IEC 61076-2-101
(Second edition – 2008)

Connectors for electronic equipment – Product requirements –
Part 2-101: Circular connectors – Detail specification for M12 connectors with screw-locking

CORRIGENDUM 1

Figure 21 – Pin front view A-coding

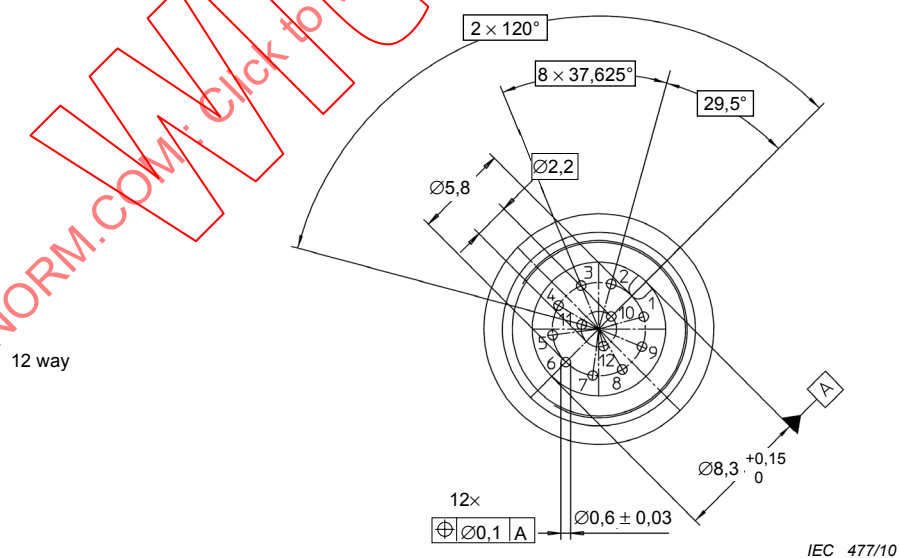
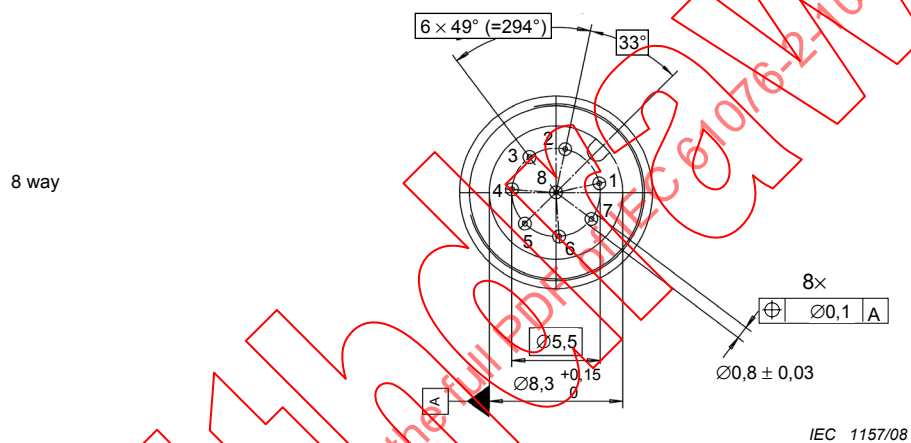
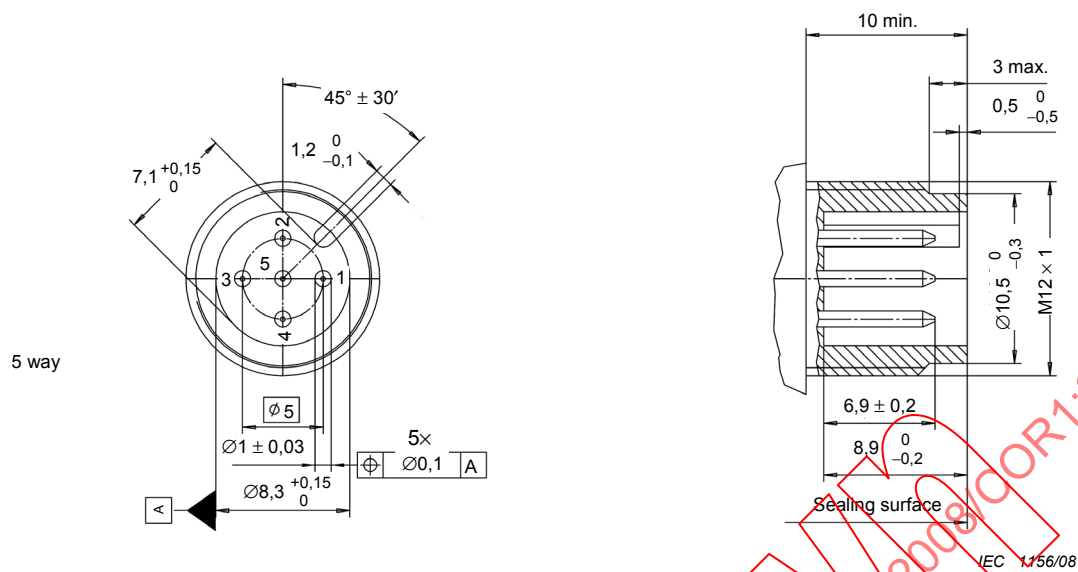
*Replace existing **Figure 21 – Pin front view A-coding** by the following:*

Figure 27 – Pin front view 5 way with C-coding

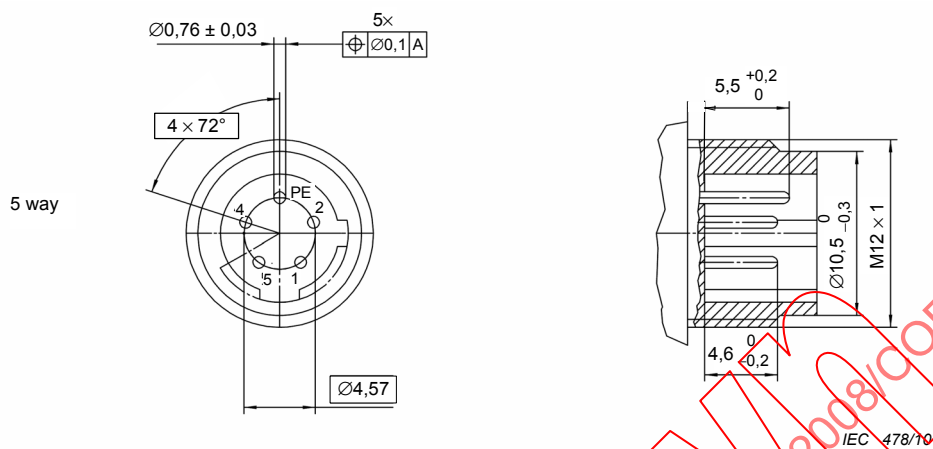
Replace existing Figure 27 – Pin front view 5 way with C-coding, by the following:
